Access Compliance Report Public Rights-of-Way (Curb Ramps)

Main Street: PALOMAR_WAY Cross Street: FAIRHAVEN_AVE Location: NE

ADA ID: RPAT211022092211 Ramp Type: Type 4 - Parallel Initial Pass/Fail: Fail Overall Compliance: No Severity Score: 15

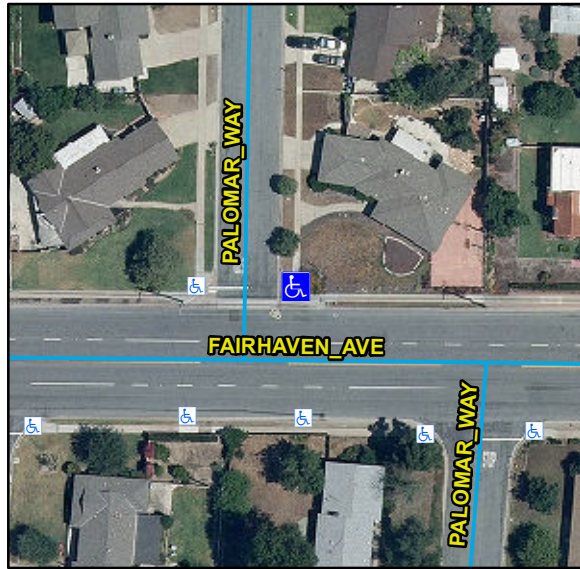
Compliance	Description	Data	Compliance	Description	Data
N/A	Ramp Length LT (in)	115	N/A	Ramp Length RT (in)	144
Yes	Ramp Width LT (in)	63	Yes	Ramp Width RT (in)	54
Yes	Ramp Run Slope LT (%)	6.2	Yes	Ramp Run Slope RT (%)	7
No	Ramp Cross Slope LT (%)	3.1	No	Ramp Cross Slope RT (%)	6.5
N/A	Landing Present	N/A	N/A	DWS Provided	N/A
N/A	Landing Length (in)	N/A	N/A	DWS Contrast	N/A
N/A	Landing Width (in)	N/A	N/A	DWS Length (in)	N/A
N/A	Landing Run Slope (%)	N/A	N/A	DWS Full Width	N/A
N/A	Landing Cross Slope (%)	N/A		DWS Offset Type	N/A
N/A	Landing Movement Obstructed?	N/A	N/A	DWS Offset Left (in)	N/A
	Landing Movement Type	N/A	N/A	DWS Offset Right (in)	N/A
N/A	Landing Shared	N/A			
N/A	Clear Space	Yes			
N/A	Clear Space To Crosswalk (in)	N/A			
N/A	Marked Crosswalk 1	No	N/A	Marked Crosswalk 2	No
	Crossing 1 Direction	W		Crossing 2 Direction	S
	Marked Crosswalk 1 Width (in)	N/A		Marked Crosswalk 2 Width (in)	N/A
N/A	Ramp Inside Crosswalk 1	N/A	N/A	Ramp Inside Crosswalk 2	N/A

Crossing 1 Slope (%)	0.7		Crossing 2 Slope (%)	5.5
	Crossing 1 Cross Slope (%)	0.7		Crossing 2 Cross Slope (%)	1.9
N/A	Gutter Ponding	N/A	N/A	Curb Slope	10.2
Yes	Gutter Lip Height (in)	0		Road Run Slope (%)	0.3
N/A	Gutter Run Slope (%)	N/A		Road Cross Slope (%)	1.7
N/A	Gutter Cross Slope (%)	N/A	Yes	Perpendicular Joint Present	Yes
Yes	Overall Surface Condition	Acceptable			
	Cross Gutter Present?	Yes		Spandrel Present?	Yes
	Replace Cross Gutter?	No		Replace Spandrel?	No

Remove & Replace Curb Ramp With Two New Directional Ramps or Equivalent.

R304.5.3, STD 1115
